**DEVIATION REQUEST  
AND DECISION FORM**

Project Name : Hillside at Lorson Ranch  
 Schedule No.(s) : 5500000370, 5500000371, 5500000405, 5500000281, 5500000282, & 5500000283  
 Legal Description : See Attached

A deviation from the standards of or in Section 2.2.5 (E) of the Engineering Criteria Manual (ECM) is requested.

DEVIATION 1  
 EXHIBIT

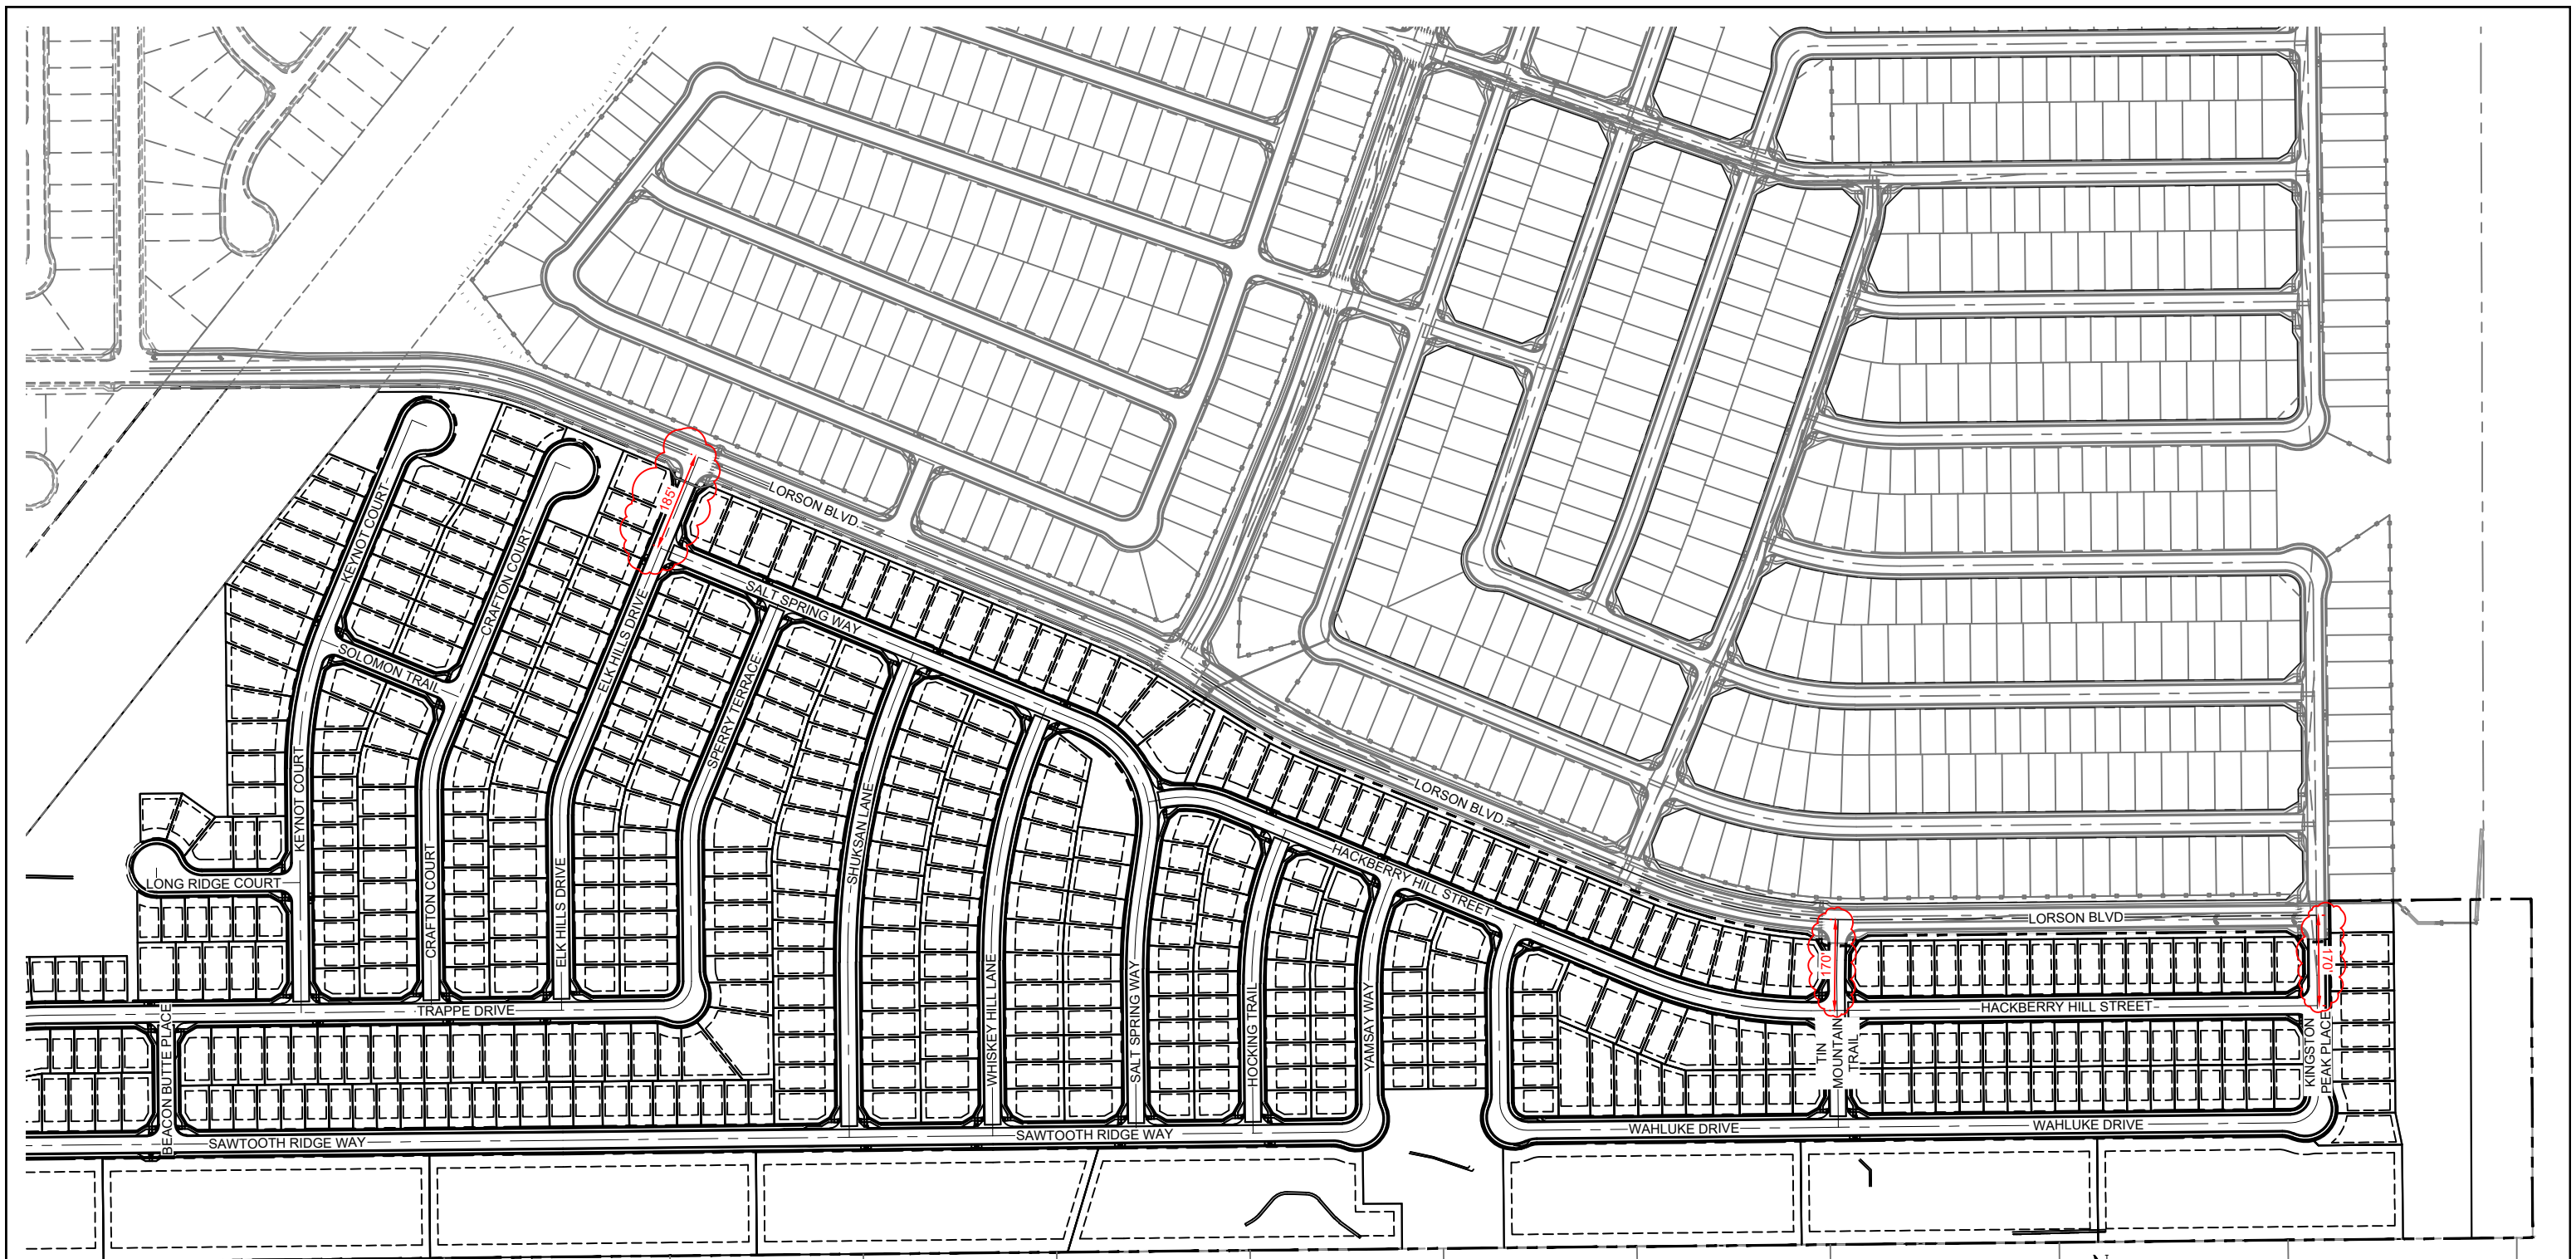
Provide file no. on  
all pages

Provide stamp and  
signatures.
